Product Change Notification

| Date Issued : | November 15, 2022 | PCN Number : | 512774 |
| Description of Change : | This notification is to inform about part(s) listed will undergo changes to the design for series 78171000X & 205871000X embossed tape. No changes will be made to the product as a result of this change. | | |

Before Picture

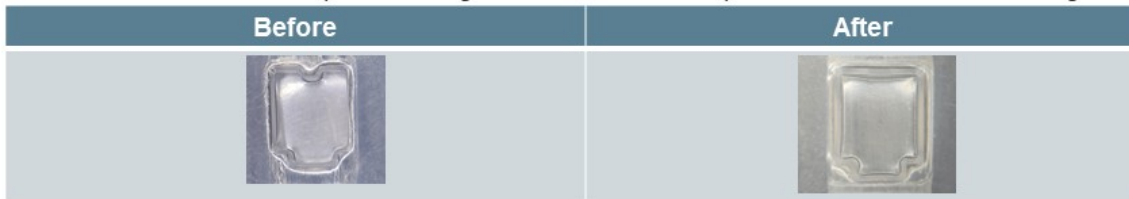
- For 78171 series & 205871 series embossed tape design change which to ensure continuous improvement and prevent damage housing issue recurrence.

After Picture

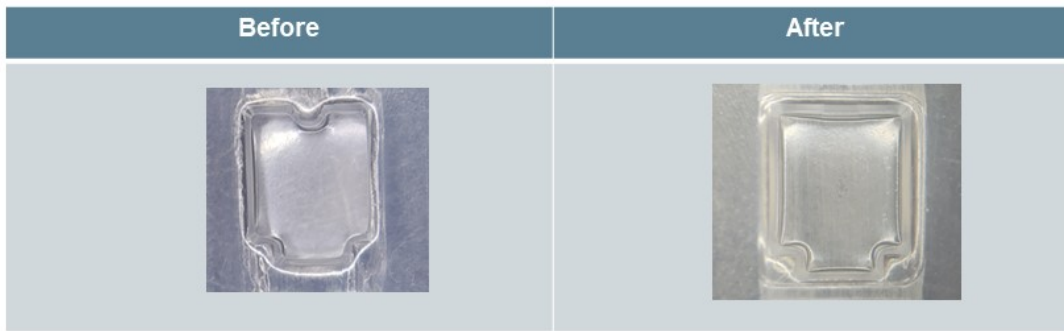
- This notification is to inform about part(s) listed will undergo changes to the design for series 78171000X & 205871000X embossed tape. No changes will be made to the product as a result of this change.

- Molex Malaysia Part Number(s) Affected: Refer to part number listed
- Product Impact
 - This change is to ensure continuous improvement and prevent damage housing issue recurrence. The material is produced per Molex specification. There is no change in product design and process for Molex Malaysia, therefore no change in the Molex assembly part number will occur either.
- Qualification/Drop test available upon request.
